UNITED STATES PATENT AND TRADEMARK OFFICE

Office Action Summary

09/236,373

BUHLER, BRUCE A.

FIGURE 5

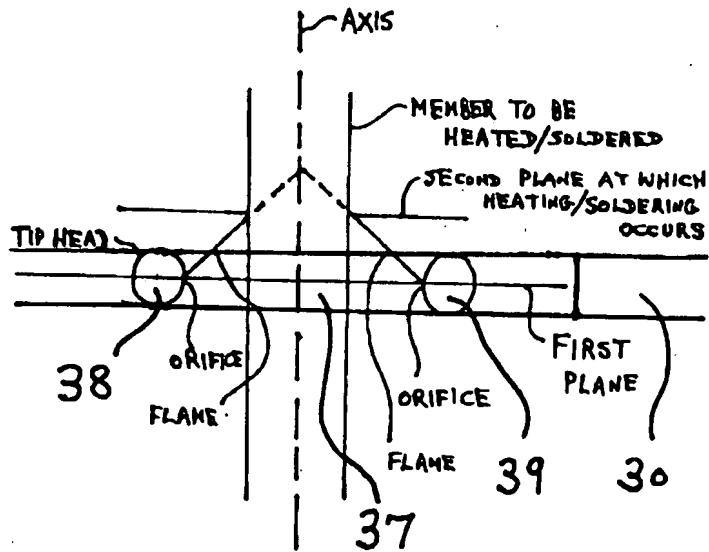
The amendment filed 09/24/2007 is objected to under 35 U.S.C. 132(a) because it introduces new matter into the disclosure. 35 U.S.C. 132(a) states that no amendment shall introduce new matter into the disclosure of the invention. The added material which is not supported by the original disclosure is as follows: There is no support in the original disclosure for the manner in which the various elements of the newly submitted drawing figure 2 are illustrated.

The drawings are objected to under 37 CFR 1.83(a). The drawings must show every feature of the invention specified in the claims. Therefore, the ports being angularly oriented to generate flames extending from first to a second plane, etc. and the flames projecting outwardly with respect to the first plane to achieve heating along the second plane (see, for example, the last paragraph of claim 1 (amended)) must be shown or the feature(s) canceled from the claim(s). These structural details are essential for a proper understanding of the disclosed invention since applicant has amended the claims to include these limitations in an attempt to distinguish the claimed invention over the prior art of record. No new matter should be entered.

NOT
ACCEPTED
NOT
ACCEPTED
9/27/07

Applicant is required to cancel the new matter in the reply to this Office Action.

Corrected drawing sheets in compliance with 37 CFR 1.121(d) are required in reply to the Office action to avoid abandonment of the application. Any amended replacement drawing sheet should include all of the figures appearing on the immediate prior version of the sheet, even if only one figure is being amended. The figure or figure number of an amended drawing should not be labeled as "amended." If a drawing figure is to be canceled, the appropriate figure must be removed from the replacement sheet, and where necessary, the remaining figures must be renumbered and appropriate changes made to the brief description of the several views of the drawings for consistency. Additional replacement sheets may be necessary to show the renumbering of the remaining figures. Each drawing sheet submitted after the filing date of an application must be labeled in the top margin as either "Replacement Sheet" or "New Sheet" pursuant to 37 CFR 1.121(d). If the changes are not accepted by the examiner, the applicant will be notified and informed of any required corrective action in the next Office action. The objection to the drawings will not be held in abeyance.
